1, 5, 5A, 7 GLADYS AVENUE

FRENCHS FOREST NSW

DA Submission
February 2023

3.0 PLM & DSAP & Design Evolution / 3.01 Overview

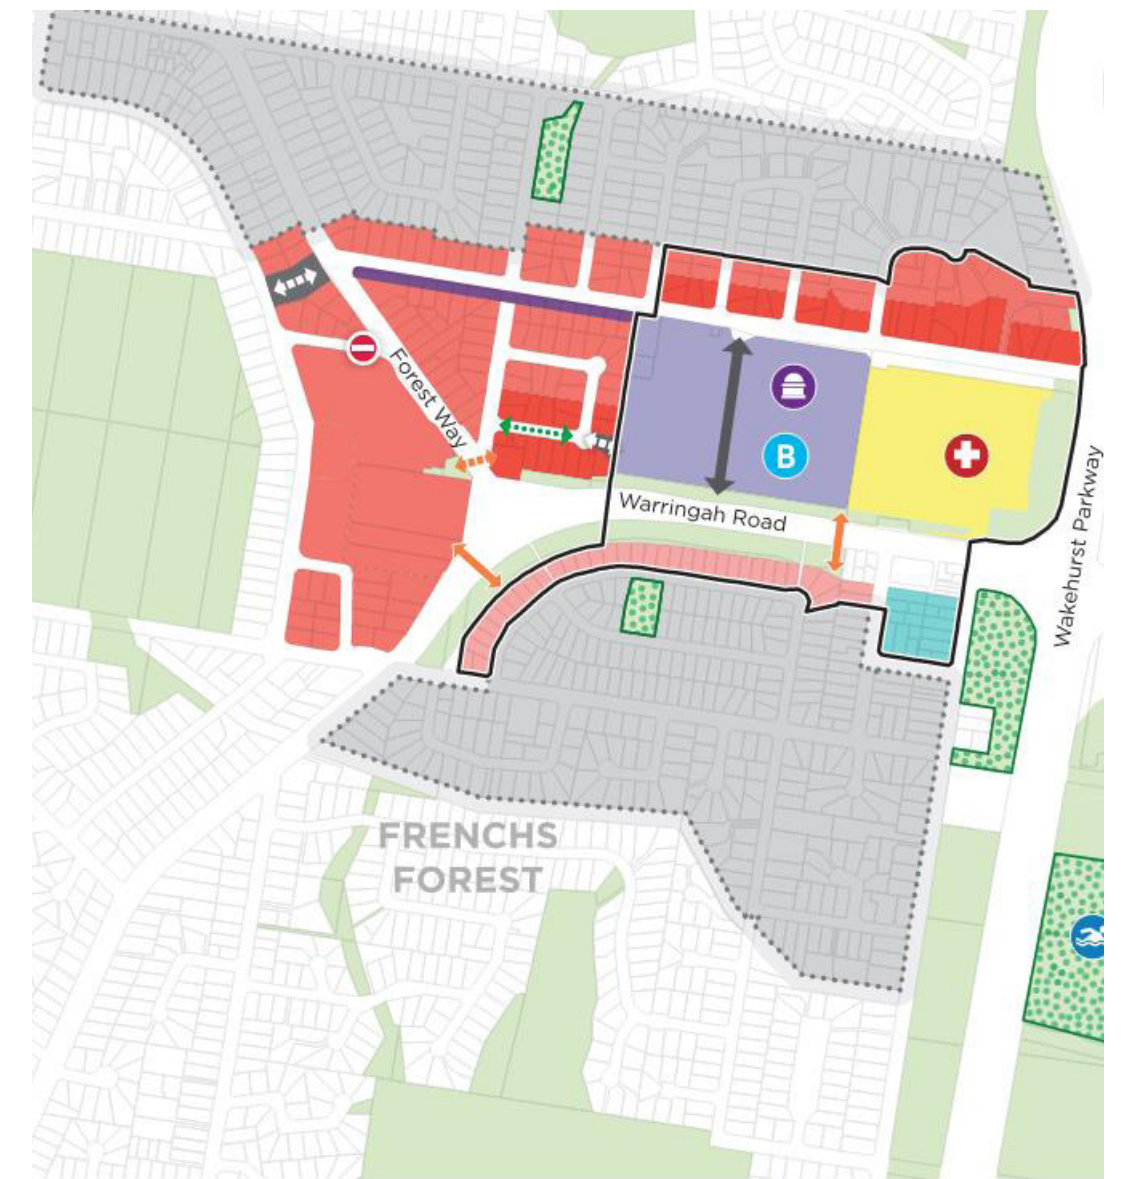
1. Site analysis. For guidance refer to the ADG Appendix 1 Site Analysis checklist, but add future context assumptions in areas undergoing urban renewal and adjacent R2 zoned areas. Identify the desirable elements of the areas existing character and future character including identifying significant and endemic trees within 6m of site boundaries and in the adjacent public domain and visual catchment. Particular attention should be paid to the isolated site.

2. At this stage an options study of masterplan solutions should be developed showing contextual and site analysis to ensure the fundamental design principles are in place. Architectural detail is not required at this stage.

3. The first step is to identify where endemic and significant trees are located and then plan the building footprints so that these trees are substantially retained. Trees within the site are just as important as those in the street frontages.

4. Refer to SMEC Biodiversity Assessment Report dated October 2014 prepared for Roads and Maritime Services for the Northern Beaches Hospital for insight into landscape context and local native vegetation communities in remnant open woodland. <https://roads-waterways.transport.nsw.gov.au/projects/01documents/northern-beaches-hospital/eis/nbh-eis-stage-1-vol-2-app-f.pdf>

5. Consider options with 3 storey residential flat buildings and townhouses with basement carparking to ensure the building footprint is not excessive

In response to item 1 – relating to site analysis, we have expanded the site analysis pages to a total of 8 diagrams explaining different items. It also notes the various approvals in the R2 land with FSRs up to 0.75:1 on the R2 land. Endemic trees have been highlights, Category A trees highlighted, future master planning shown. The isolated site could have a similar townhouse proposal on it, or it could have an apartment building. This apartment scheme option is now also shown.

Response to item 2 – additional plans are included in the submission to show the consideration made to the masterplan, redevelopment options considered, the key site opportunities and constraints, along with the manner in which the proposal responds.

Response to item 3 – This amended scheme shows the endemic trees on the site on the site analysis page. Of the 5 endemic trees near the site, 3 are able to be retained. The two that are required to be removed will be replaced at a minimum of 2 to 1 ratios in line with WDCP Part G9, 5.2.8 part 2.

Response to item 4 – A preliminary Arborist Report was produced prior to the PLM and this has been updated to accompany the DA submission.

Response to item 5 – We have investigated a Residential Flat Building on the site, but the site proportions are not conducive to the larger footprint required for RFBs. The shape and proportions of the land renders it appropriate for medium density housing which the proposal (as amended) responds appropriately to. We have reduced the building footprint and increased the landscape areas.

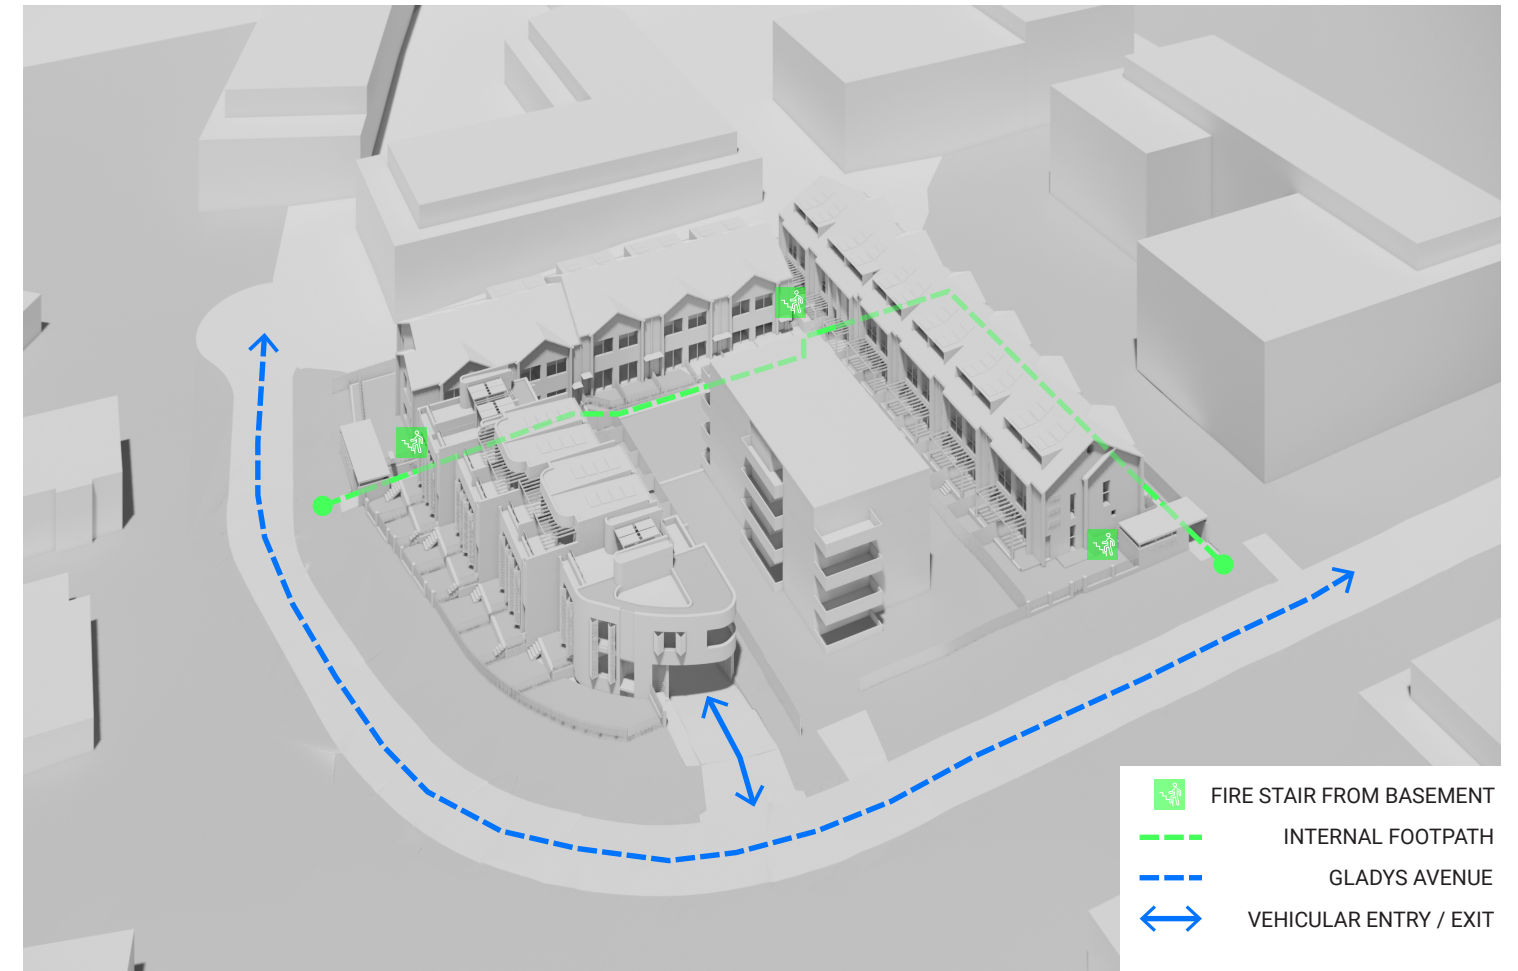
6. Provide a 6.5m deep soil front setback from the street in any solution.
7. Provide minimum 6m setbacks to side and rear boundaries as part of the character transition to R2 zoning neighbouring the site.
8. Townhouses fronting streets should be maximised in site planning.
9. Avoid single aspect south facing private open space that is required.
10. Consider alternate plans for east west facing dwellings and north south facing dwellings.

In response to item 6 – a 6.5m deep soil front setbacks has been provided in the amended drawings submitted with the Development Application.

In response to item 7 – the site is nearby R2 zoning but it has no side boundaries or rear boundaries adjoining a R2 zoning or RE1 zoning and thus is not required to have a 6m side setback (requirement 3 of WDCP G9 5.2.3). There are buildings across the street that are in an R2 zoning, the local development character has been considered along with some recent approvals on these properties. The following are noted:

In response to item 8 – townhouses at the North West of the site have been rotated to face towards the street. This now means 10 townhouses have a street frontage in the DA application.

In response to item 9 – the southern row of townhouses have now been mirrored and the footpath moved to the southern side of the building. This means that townhouses 1 to 12 are north facing townhouses.

Townhouses 13 to 22 have dual aspect orientation with their principal POS on the eastern side. Townhouses 23 to 30 also have dual aspect, and they have generous northern front gardens which will be off the dining area. This now satisfies the recommendation.

In response to item 10 – we have developed the planning of the townhouses so that there are variations of types across the site. Whilst on paper the floor planning across the site, changes have had to be made to each plan such that there are 8 unit types across the site. There has also been changes to the dwellings that face the street, most notably the townhouse 23-30 which have great northerly aspect but their main POS is on the south side as they are addressing the street. This means we have allowed for a third garden space by incorporating rooftop terraces with northerly aspects so there is a range of garden settings.

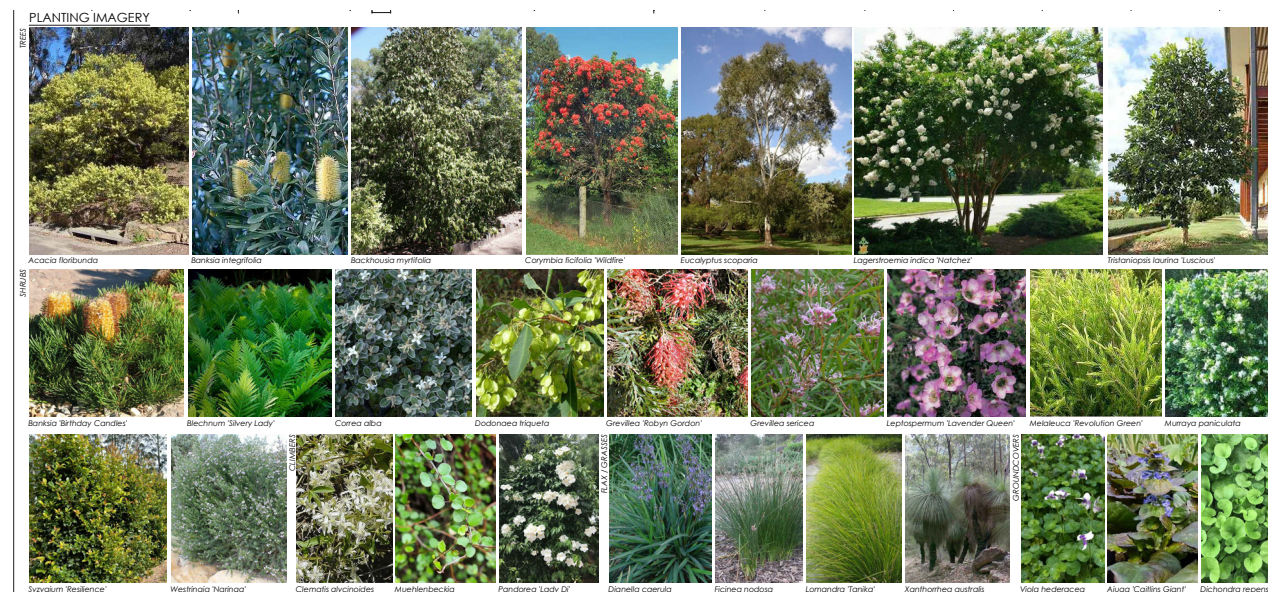
11. Townhouses fronting streets should have direct entries from the street.
12. Where townhouses are proposed that do not have street frontage the lane network needs to be of a scale and configuration that will provide the equivalent of a publicly accessible ungated 'new street' address. Typically, this would require a minimum 6m wide landscaped pedestrian street (boundary to built form) with good sightlines and overlooked for neighbourhood safety. Generous landscaping should be provided along pathways adjacent to boundaries. Pathways should be minimum 1.5m wide. Each townhouse should have a private entry garden to access the internal streets.

13. Internal pedestrian streets should connect to local streets at each end and avoid cul de sac conditions.
14. Consider alternative locations of internal pedestrian streets including access along the southern boundary of No.1 Gladys so that private open space is located north of dwellings. Present alternatives considered and the reasons for preferred site planning in future DSAP meetings.

15. Consider waste collection in the master plan phase.

In response to item 11 – the amended scheme now has 10 townhouses fronting the street, and all of these will have access points direct from the street.

In response to item 12 – the walkway design has been considered further with council and our landscape architect. The internal street will have a landscaped zone on each side of the walkway, and there are small private courtyards before accessing the front door of the property. The walkway on the southern side is now all deep soil which will allow for the planting to become more established with time. These landscape areas will be maintained by the Strata Body which will ensure they continue to flourish to ensure that they create nice walkways.

Further to the above, each townhouse that addresses the street does have a private garden entry. Council has requested that the first 2m of landscaping remain common property, so these gardens all start 2m back from the street frontage.

In response to item 13 – the walkway connects to the local street at each end and avoids cul-de-sac conditions. We have also undertaken a desktop CEPTED assessment prior to lodging the Development Application and we have ensured that there are no areas along this path that are unsafe. Casual surveillance from inside each townhouse is provided, and we have tried to close off any cul-de-sac areas which are unsafe by introducing additional gates with security to ensure only owners can use this area (such as the walkway outside TH 10-12 or fire stairs adjacent to TH13).

In response to item 14 – this recommendation has now been adopted. All townhouses along the southern edge of 1 Gladys have been mirrored so that all the principal POS are on the northern side.

In response to item 15 – the waste collection has now been shown in accordance with Northern Beaches Waste Management Policy Chapter 4. There are two bin areas given the large extent of the site, but both areas are within 6.5m of the front setback as required in Part 4.6 of the Policy. 2 bays are provided in 2 locations to aid accessibility and proximity to residents within the site. The size requirements met for the required number of bins, and this has been presented to both Council Planning and Waste Teams. Their Waste team asked for an increase in size and a roof must be put on it, which planning agreed with. This has been agreed to and is now shown in the Development Application Drawings.

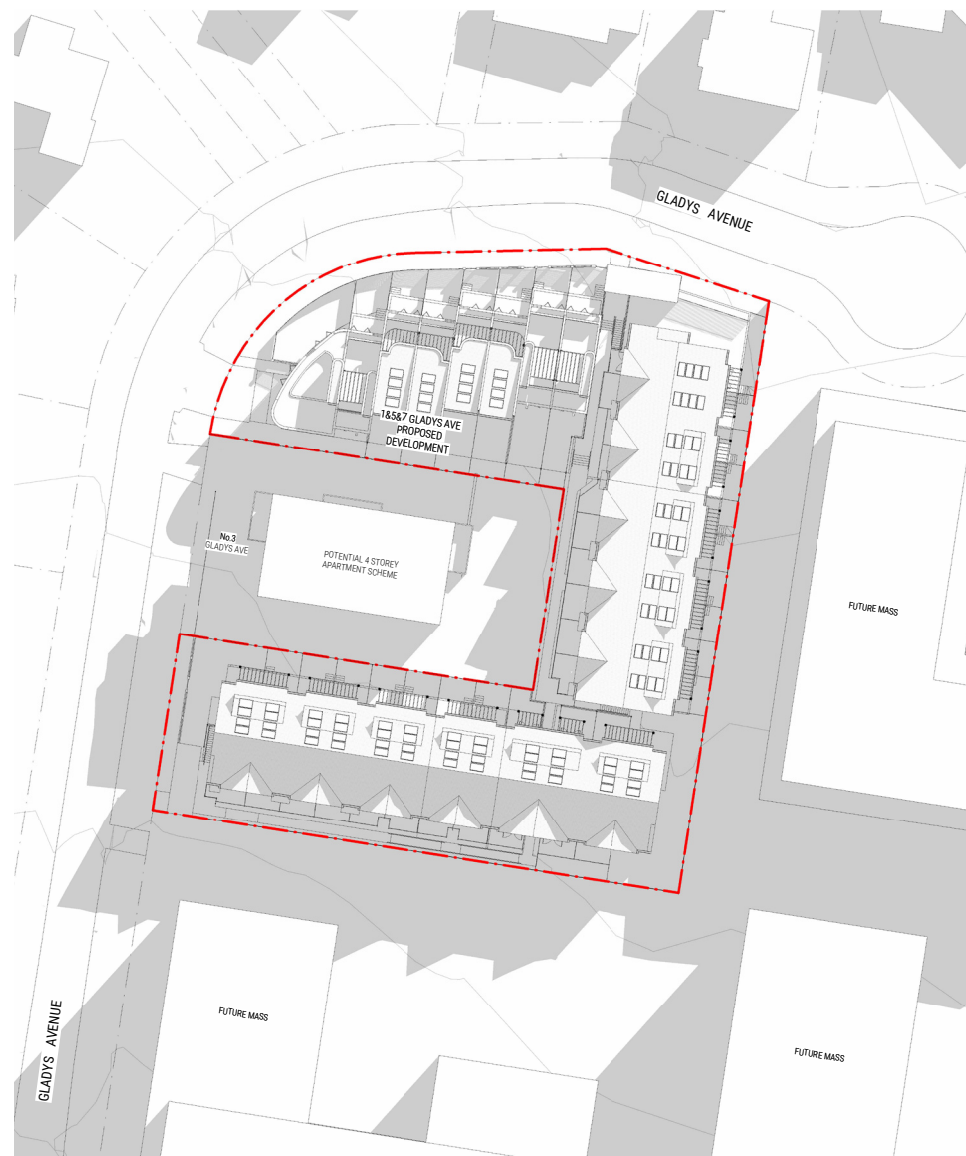
16. The design should start with considering a detailed site analysis including context analysis and understanding of existing trees suitable for retention.
17. The existing trees must be given priority and have both environmental and amenity value for residents as well as contributing to the character of the area.
18. The trees and their retention should be utilised to inform how the development character may be developed, how they might create spaces and inform circulation.
19. The basement must be minimised in order to allow deep soil for landscape for the existing trees and the landscape for the dwellings.
20. Entry, circulation and street presence are critical to setting up the site masterplan and creating a positive intervention into the urban realm.

In response to item 16 – the detailed site analysis has been included as part of the amended application. The endemic trees are mapped on one diagram, and all category A1 or A2 trees are also mapped on another diagram.

In response to item 17 – the amended application now includes 11 Category A trees being retained on or around the site. There are 27 trees to now be demolished, all of which will be replaced at a minimum ratio of 2 to 1 in line with WDCP Part G9, 5.2.8 part 2.

In response to item 18 – we have looked at alternative schemes, but it would render the sites of 5, 5a and half of 7 undevelopable. There would be approximately 825m² of the site area left as developable, which is less than 23.5% of the site area left to build on. This is not feasible or an appropriate outcome for the land or the development planned for the area.

In response to item 19 – the basement footprint has been significantly reduced to allow for over 28% of the site to be deep soil. A further 15% of the site will have at least 1m deep planting on top of the basement which is in excess of the requirement.

In response to item 20 – we have made further amended the plans. We submit that the entry, circulation, and street presence create 'a positive intervention into the urban realm'.

Proposed Shadow Diagram - 9am June 21st

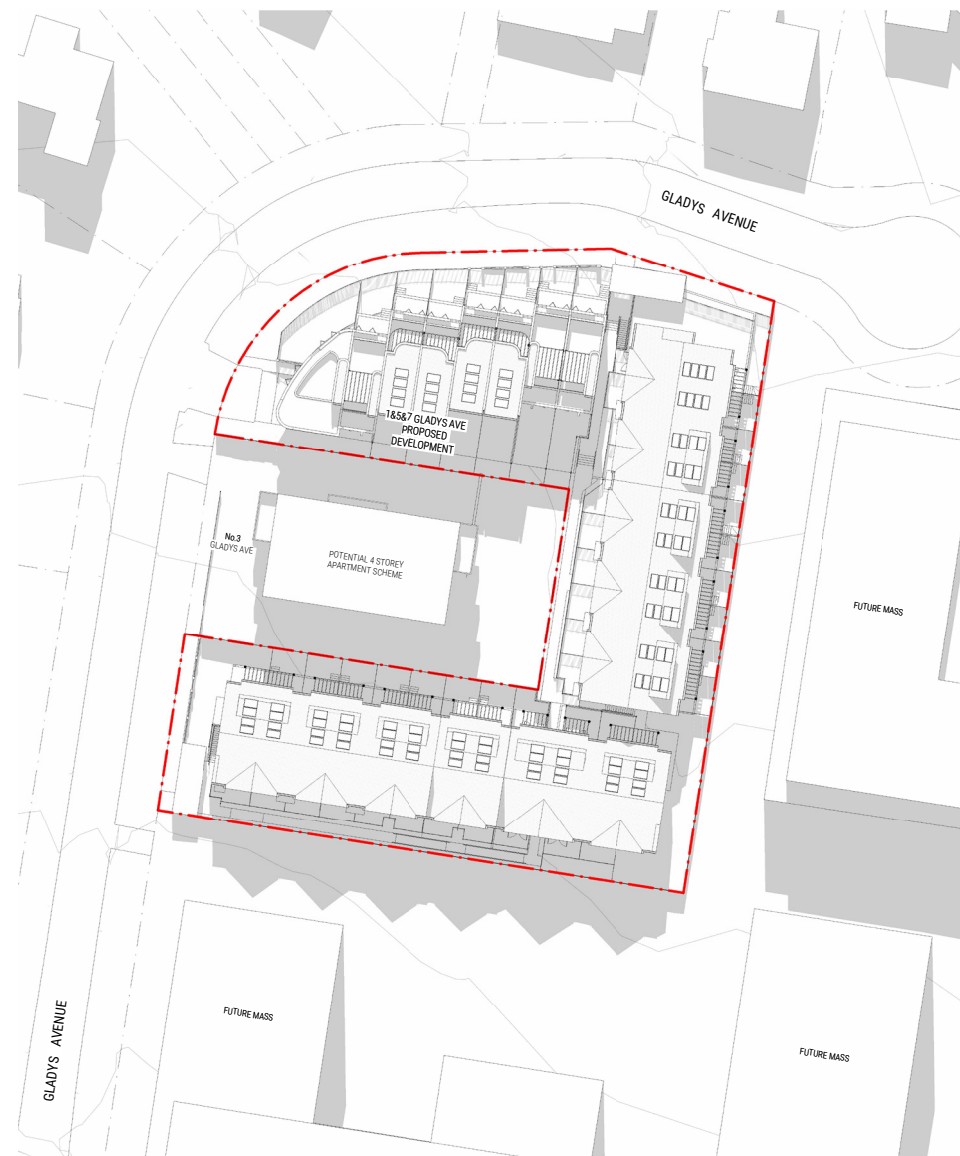
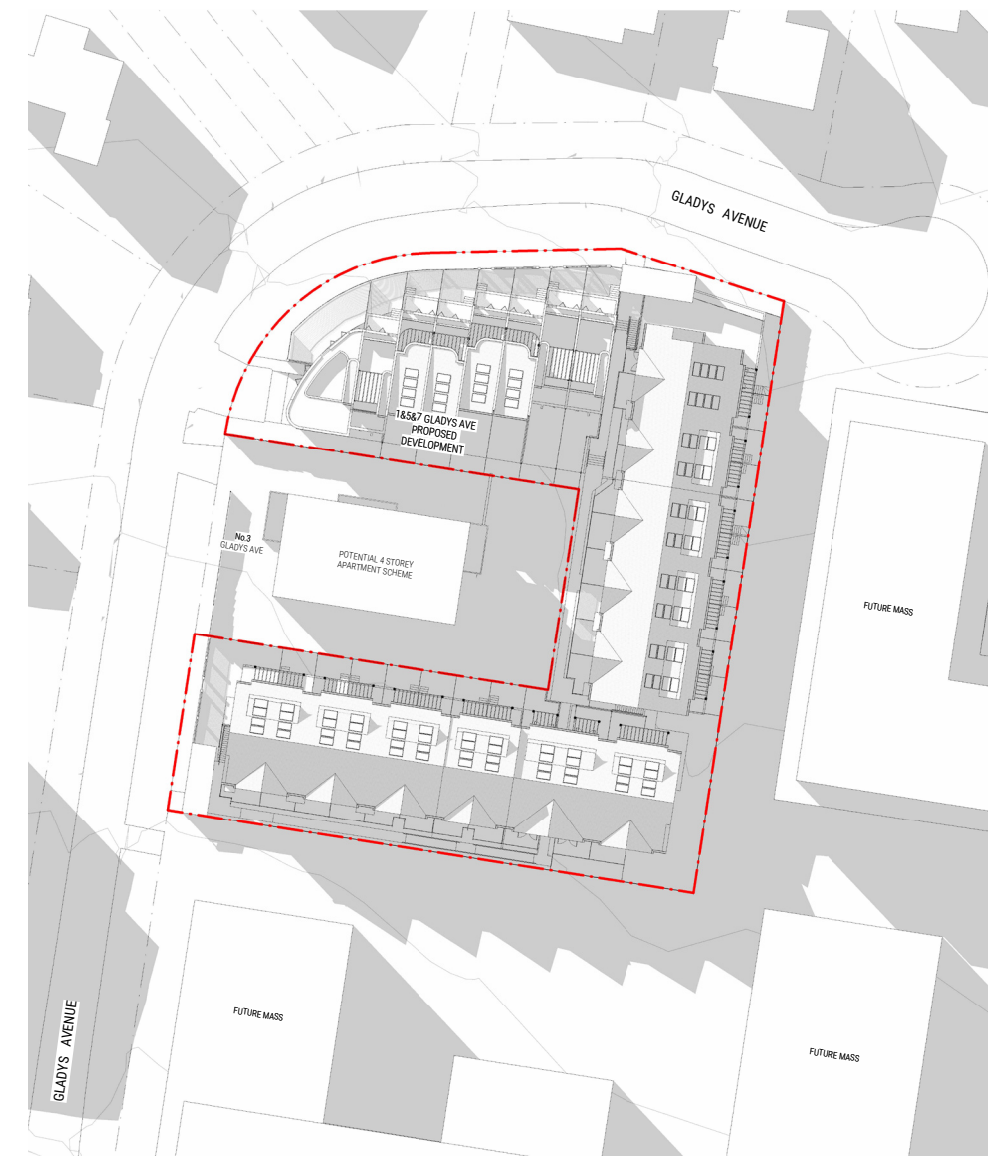
21. Built form analysis should consider overshadowing and privacy to existing dwellings and private open space adjacent.

In response to item 21 – the properties to the south are all earmarked for development as development with an FSR of 2:1, a 3.5m setback to the southern boundary, zero setbacks to their side boundaries and a total height of 17.5m. That results in the building massing of these sites being on the far south of the development sites (and ground floor is most likely commercial). The overshadowing from any of our development site should not overshadow any future residential dwellings on those southern sites. We have also investigated the overshadowing to 3 Gladys Ave and under a future RFB proposal, all 12 units have solar access compliance, and 11 of those have a full 6 hours of sun with the last unit having 5 hours. This is great solar access compliance.
